To: Quinault Indian Nation

From: Natural Systems Design, Inc.

Re: CASCADE OF FRE FACILITY ECOSYSTEMS EFFECTS TECHNICAL MEMO

Figure 3. Keechelus Dam Reservoir, illustrating 'ring' of impacted vegetation in zone of water level fluctuation. Source: U.S. Bureau of Reclamation: <u>https://www.usbr.gov/projects/index.php?id=294</u>

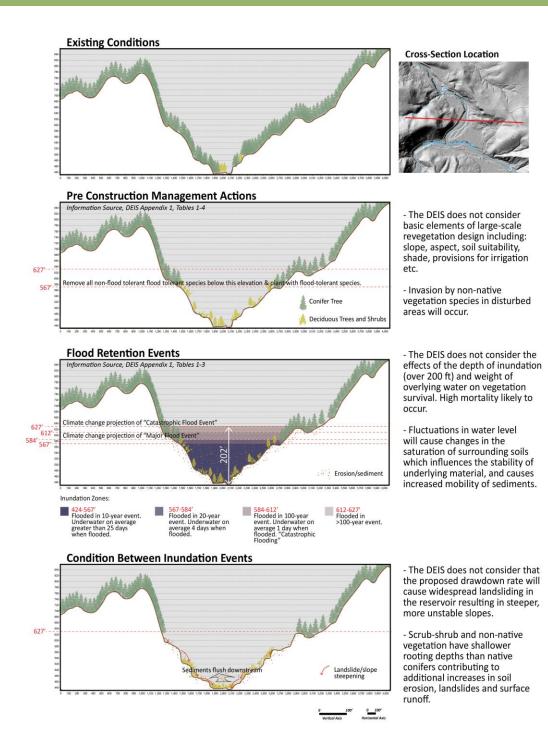
Within riparian areas, the conversion from mature coniferous forest to a willow-dominated scrub-shrub community will affect water quality through the drastic reductions in shading and large wood recruitment. Figure 3 illustrates a 'ring' of similar vegetation impacts around the flood control reservoir at the Keechelus dam on the upper Yakima River, Washington. Riparian forest conversion impacts directly degrade local aquatic habitat quality due to increased water temperatures, reduced in-stream cover, and reduced in-stream organic material (Moore et al. 2006; Tockner et al. 1999). In addition, the reduction in large wood recruitment will indirectly degrade aquatic habitat quality by impairing geomorphic processes that depend on large in-stream wood, such as pool creation and retention of spawning gravels (Montgomery et al. 2003).

The maintenance needed to prevent the 514 acres of logged area from being overrun by early successional, weedy and/or invasive plant species between periods of inundation is ignored, as is the consequence of water level regulation on vegetation community composition (Nilsson et. al. 1997; Hill et. al. 1998). Furthermore, the DEIS focuses on projected tolerance of Pacific Northwest tree and shrub species to the depth and duration of typical riverine surface inundation (I.e. 1 to 25 days inundation at depths of 165 to 202 feet of water, late century major and catastrophic flood reservoir depths respectively [DEIS Exhibit 2-4 and Appendix P, Figure P-17 and Table P-14]) in considering vegetation survival and changes to community composition. The analysis of impacts to vegetation within the reservoir fails to consider the depth of inundation and weight of the impounded water when predicting survival and community composition of vegetation on the slopes or along the river as a result of FRE facility closure. Figure 3 illustrates the type of characteristic zone of periodically impacted vegetation that forms around reservoirs where water levels fluctuate as the reservoir is filled and drained. Lastly, given that the frequency and duration of inundation are underestimated and backwatering is not addressed, the impacts of inundation to contribute to the cycle of repeated loss of native trees, shrubs and

Figure 6. DEIS exhibit 3-2

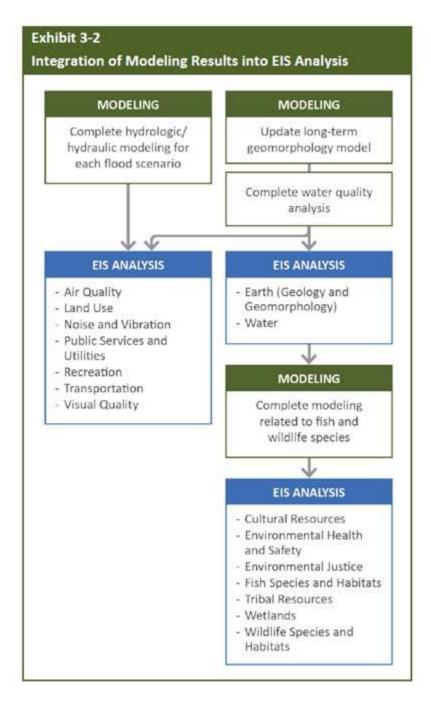
The conclusions reached by the hydraulic and geomorphic impact assessments are used as the basis for evaluating impacts to all other resource areas. This is underscored by DEIS Exhibit 3-2 (p. 32) (Figure 6 herein) and Section 3.4 of the DEIS which states:

Because there are demonstrated flaws in the hydraulic and geomorphic modeling approaches, all analyses that depend on those models are inadequate. Just as changes in first-order hydrology, sediment supply and water quality cascade through the riverine and riparian ecosystems as second-, third-, and fourth- order effects, the results of the hydraulic and geomorphic modeling also propagate through the analysis, affecting all impact determinations. This includes the magnitude and the spatial extent of the impact assessments for all resource areas presented in Figure 6.
